Access Compliance Report

Public Rights-of-Way (Curb Ramps)

Intersection ID: 14235	Main Street: CAMDEN_RD	Cross Street: E_TREMONT_AV	Location:	E
ADA ID: F1D8790AAFE0	Ramp Type: BlendTrans1	Initial Pass/Fail: Fail	Overall Compliance: No	Severity Score: 25

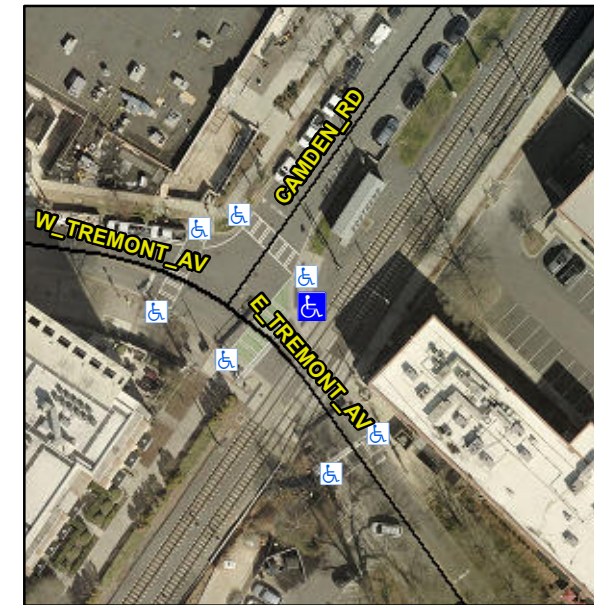
Compliance	Description	Data	Compliance	Description	Data
N/A	Ramp Length (in)	60.0	Yes	BlendTrans Slope (%)	3.4
Yes	Ramp Width (in)	110.0	No	BlendTrans XSlope (%)	8.2
N/A	Flare Type LT	N/A	N/A	Flare Type RT	N/A
N/A	Flare Slope LT (%)	N/A	N/A	Flare Slope RT (%)	N/A
N/A	Flare Traversable LT?	N/A	N/A	Flare Traversable RT?	N/A
N/A	Landing Length (in)	N/A	N/A	DWS Provided?	N/A
N/A	Landing Width (in)	N/A	N/A	DWS Contrast?	N/A
N/A	Landing Slope (%)	N/A	N/A	DWS Length (in)	N/A
N/A	Landing X Slope (%)	N/A	N/A	DWS Full Width?	N/A
N/A	Landing Curb? (Y/N)	N/A	N/A	DWS Offset (in)	N/A
N/A	Shared Landing?	N/A			
N/A	Gutter Ponding?	N/A	N/A	Gutter Slope (%)	N/A
N/A	Gutter Lip Ht (in)	N/A	N/A	Gutter X Slope (%)	N/A
N/A	Painted X Walk1?	Yes	N/A	Painted X Walk2?	N/A
	X Walk 1 Direction	To SW		X Walk 2 Direction	N/A
	X Walk 1 Width (in)	144.0		X Walk 2 Width (in)	N/A
	X Walk 1 Slope (%)	7.4		X Walk 2 Slope (%)	N/A
	X Walk 1 X Slope (%)	2.4		X Walk 2 X Slope (%)	N/A

Remove & Replace Curb Ramp With Two New Directional Ramps or Equivalent.

R304.5.3
